First Revision No. 1-NFPA 1901-2013 [Sections 1.3.1, 1.3.2]

Figure 14.1.3.1 Dimension Lines for Measuring Seat Belt Effective Length.

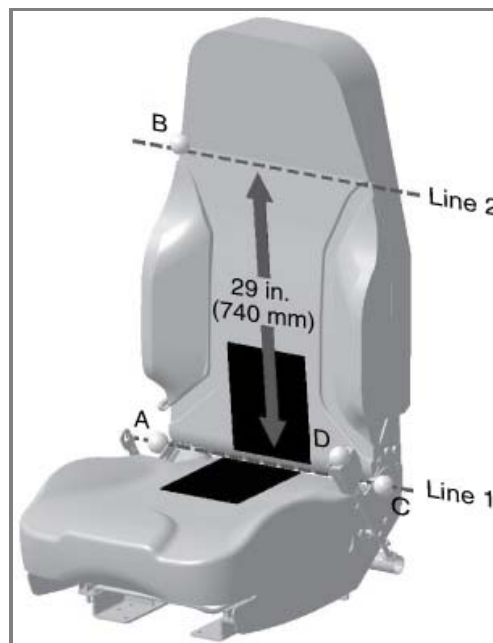
- (1) Locate an imaginary line where the plane of the center of the seat back surface intersects the plane of the center of the seat cushion surface (line 1 in ~~Figure 14.1.3.1~~ ~~Figure 14.1.3.1~~ ~~Figure 14.1.3.1~~ ~~Figure 14.1.3.2~~). For seats with an SCBA seat back, use a plane that simulates the position of an SCBA back pad installed in the SCBA holder.

Committee Statement: This change allows the manufacturer to properly measure the belt length on a dual retractor restraint. The current standard is ambiguous as it was written before dual retractors were common in the fire service. It also provides a maximum buckle stalk length to ensure that the buckle does not end up over the occupants belly, nor will it create a “tenting” action that can keep the web from being snug against the torso as it should.

- (1) Locate an imaginary line where the plane of the center of the seat back surface intersects the plane of the center of the seat cushion surface (line 1 in Figure 14.1.3.1). For seats with an SCBA seat back, use a plane that simulates the position of an SCBA back pad installed in the SCBA holder.

- (2) Locate an imaginary line parallel with line 1 and lying on the center of the seat back surface 29 in. (740 mm) from line 1 (line 2 in Figure 14.1.3.1).

The distance from the buckle anchorage to point D in Figure 14.1.3.1 (buckle tip) shall be no more than 2 in. (51 mm) longer than the distance from the buckle anchorage to the seating reference point (H-Point) of the seat when the seat is adjusted to its lowest and most rearward position.

Alternatively, for ease of measurement, the distance CD in Figure 14.1.3.1 shall be no longer than 8 in. (203 mm) with the seat adjusted to its lowest and most rearward position.

Figure A.12.1.5.1 Suggested ~~Plate Label~~ Showing Dimensions of Fire Apparatus.

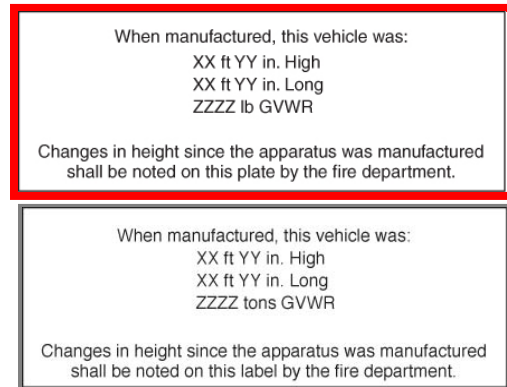
It is important for fire apparatus drivers to understand the height, length, and weight of the vehicle compared to their personally owned vehicles. It is also important that this information be accurate. Because the height of the apparatus could change after delivery, depending on what equipment might be added, the fire department ~~must~~ should note such changes on the ~~plate~~ label. Suggested wording for the ~~plate~~ label is shown in Figure A.12.1.5.1.
